RE: Marion County
CR 42 At SE 182nd Ave. Rd. Intersection Improvements
FPN.: 434844-1-58-01
FAN: D522-073-B
Contract No.: G2M09
Change Order No. 02

Change Order #02 Entitlement Analysis

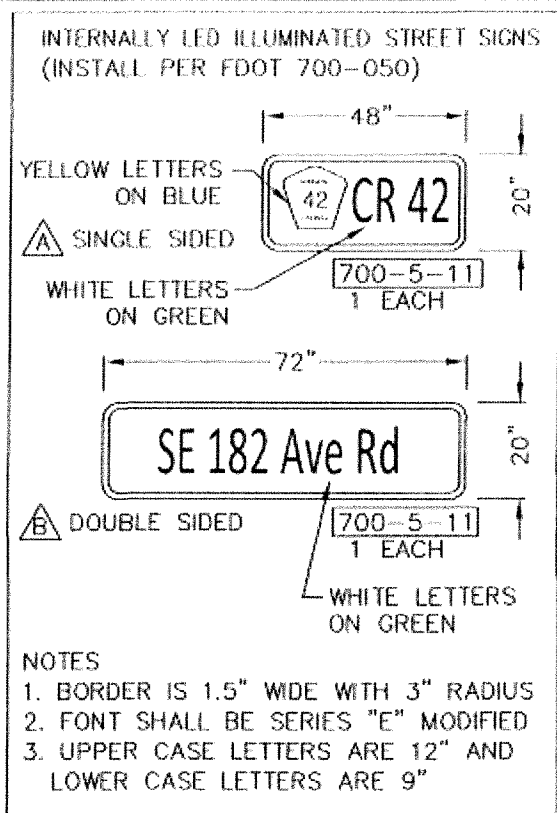
Can you issue a RFI regarding the illuminated signs for this project? It appears that the design shown on the plans was for aluminum signs not illuminated signs. Please see the comments from our signal equipment vendor and ask the EOR how they want us to proceed. He has attached two drawings to show the difference.

If we build the proper signs it appears they will have to be bigger which will also mean that the pole mounted brackets will have to be bigger as well, which will increase our pricing.

See the spec above. As you can see on the proof, I used the same spec that was provided above.

Used a 1.5" Border with 3" Radius.

Used series E Mod Font.

Used 12" upper case and 9" lower case lettering.

Also, in the layout above, the signs are blade signs. The layout does not take into account that there is a frame that needs to go around the sign.

Please see the attached preliminary drawing. To get the signs down to the size that was requested, I had to use the following specs.

Use .80" border with 1.5" radius

Use Series D font.

Use 8" upper case letter and 6" lower case letter.

The Marion County logo will need to be sized down to an 8x8" square in order to fit in the provided space.

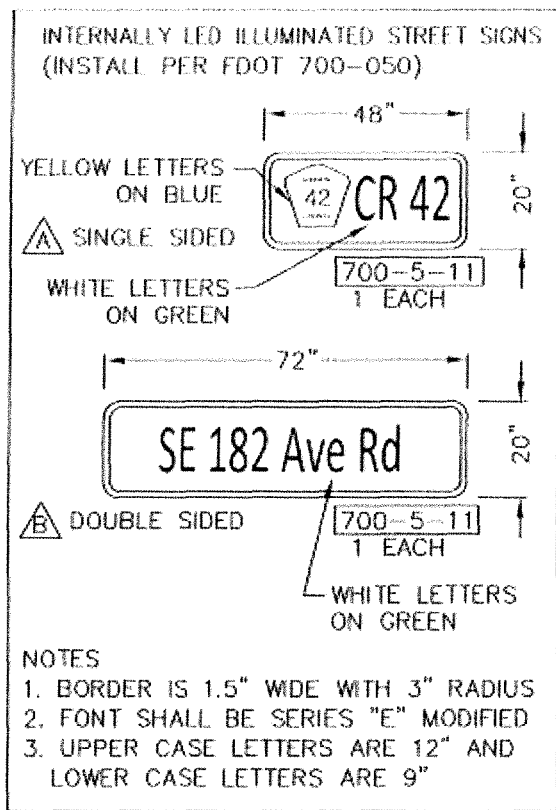
The plans called for internally illuminated signs, which is what we want installed. I'm ok with increasing the size of the signs if it's needed to fit the text.

The illuminated sign designs that Temple provided need to be revised per the comments below. Some of these comments were included in the signals submittal that we sent back for revisions.

- Letter height shown in upper right corner is 10". Revise to correct height for each sign.
- Sign B (single-sided) will not use an underhang mount. It will be rigidly attached to the cantilever arm.

- Remove the Marion County route sign logo.
- Change "CR 42" to "SE Hwy 42". This is the street name assigned by 911.

- Use "Av" instead of "Ave" for the abbreviation.
- The sign cannot exceed 9 ft per FDM 230.2.10. If needed, use E Mod font with 10" uppercase and 8" lowercase.
